Appendix G

**Summary of Agency and Tribal Feedback for
Jeffers Petroglyphs Site and Red Rock Ridge**

Big Bend Wind Project – Summary of Feedback

Figure 2
Potential Visibility Analysis

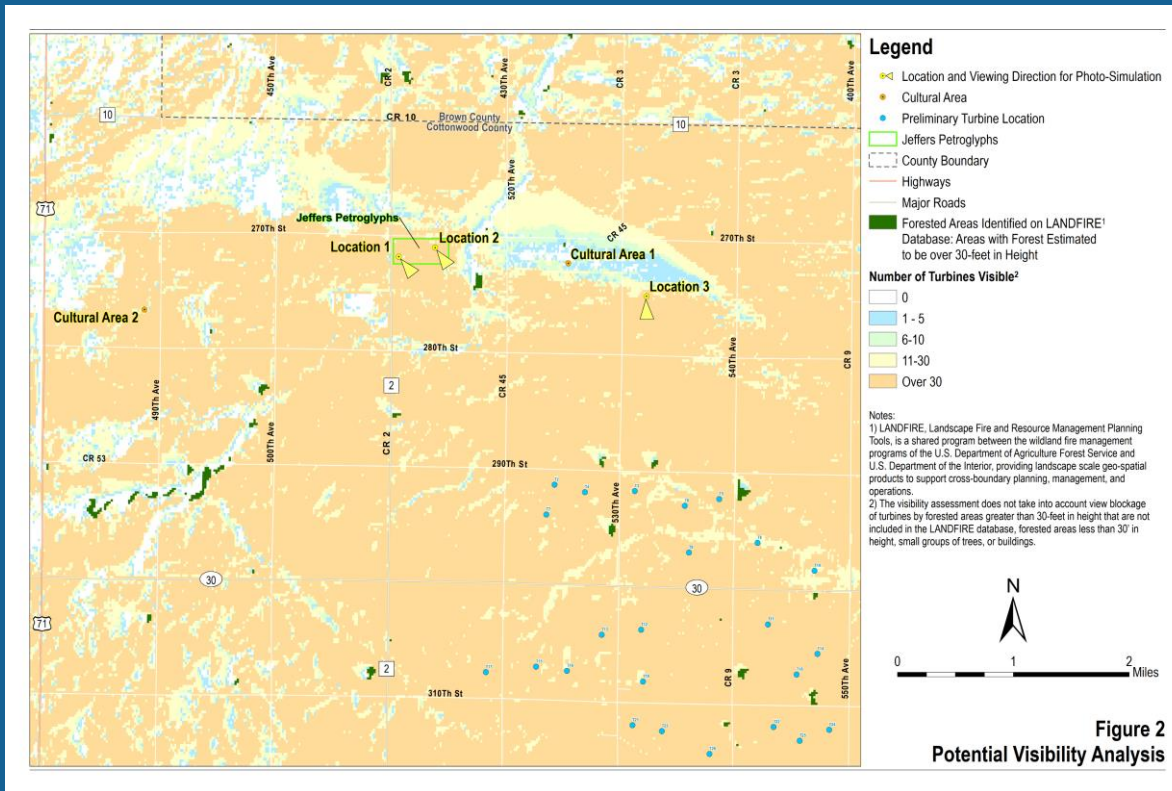
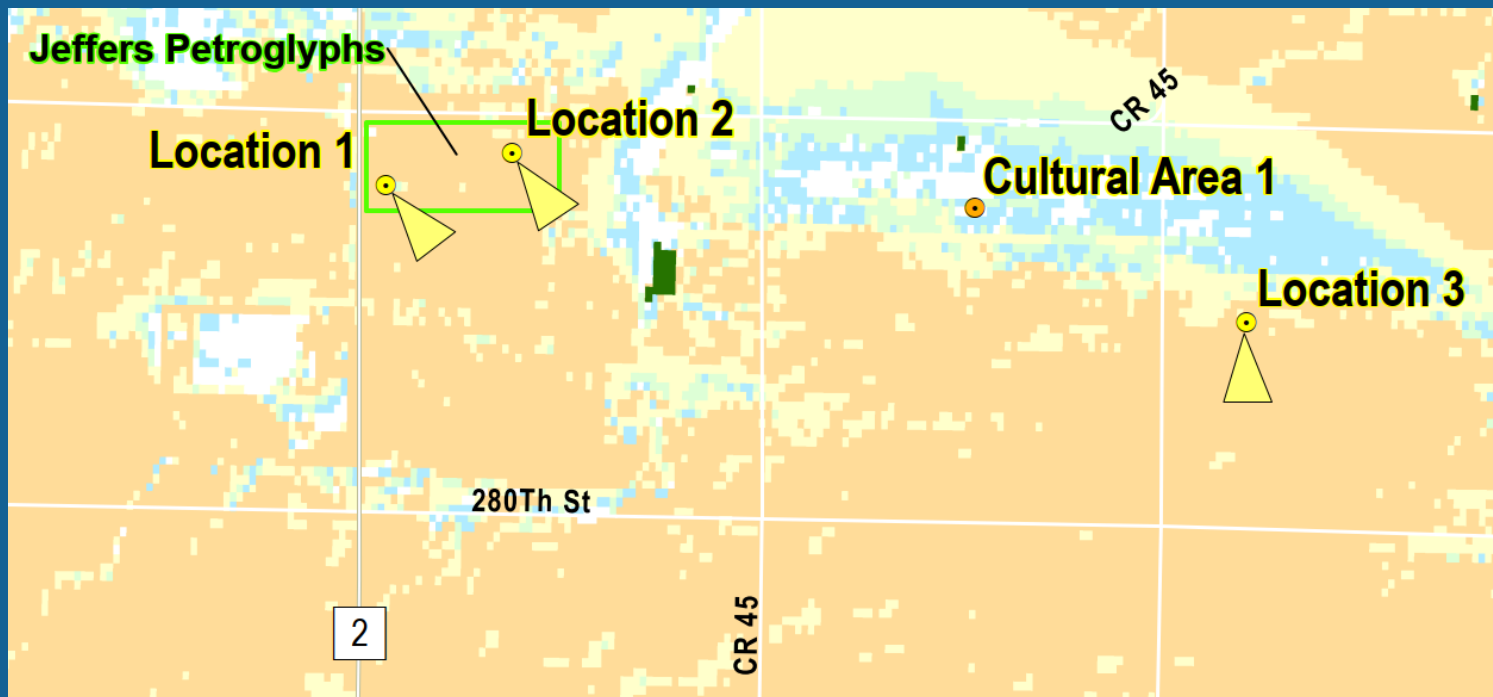
| Input received from: | Date of input: | Nature of request/concern: | Current plan to address: | Row (reference) |
|---|----------------|--|---|-----------------|
| RRRRG | 9/13/18 | Concern that the viewshed from specific observatories will be negatively impacted, especially at summer and winter solstices. | The visual simulation shared on 7/17/19 demonstrated that under the preliminary layout shared, turbines are not expected to be visible from the observatories. It was mentioned that if a turbine model with a tip height above 570 feet is selected, | 11 |

| Input received from: | Date of input: | Nature of request/concern: | Current plan to address: | Row (reference) |
|---|----------------|--|--|-----------------|
| PIIC | 4/22/2019 | Concern that the viewshed from the Jeffers Petroglyphs site and Ridge will be negatively impacted. | Big Bend conducted a visual simulation based on the preliminary layout which was shared on 7/17/19 to generate more specific feedback on visual impacts. | 22 |

| Input received from: | Date of input: | Nature of request/concern: | Current plan to address: | Row (reference) |
|------------------------------|----------------|--|--|-----------------|
| | | | there are possible turbine locations where the tips of turbine blades could be visible from the observatories. In the most current layout, turbines are not expected to be visible from the observatories. | |

Incorporating Feedback: Revising Project Boundary

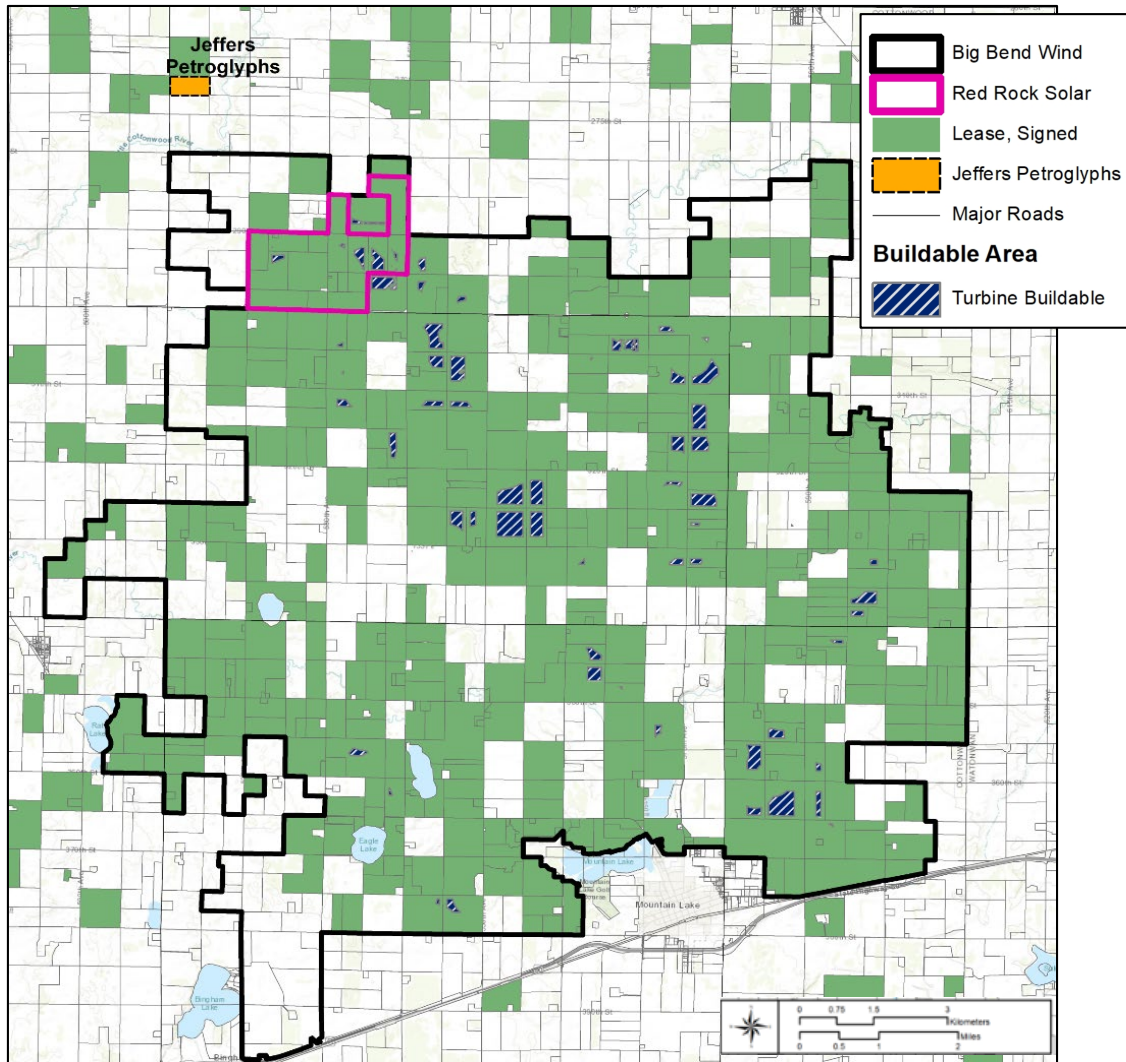
| Input received from: | Date of input: | Nature of request/concern: | Current plan to address: | Row (reference) |
|------------------------------|----------------|--|--|-----------------|
| RRRRG | 9/13/2018 | The project boundary should not include the MNHS Jeffers Petroglyphs site. | The project boundary was shifted south to avoid this site in Fall of 2018. | 12 |

- Boundary has been revised to avoid Jeffers Petroglyphs
- Current project area is >0.5 miles from Jeffers Petroglyph site
- As currently planned, the nearest turbine will be 2.3 mi from SE corner of Jeffers Petroglyphs
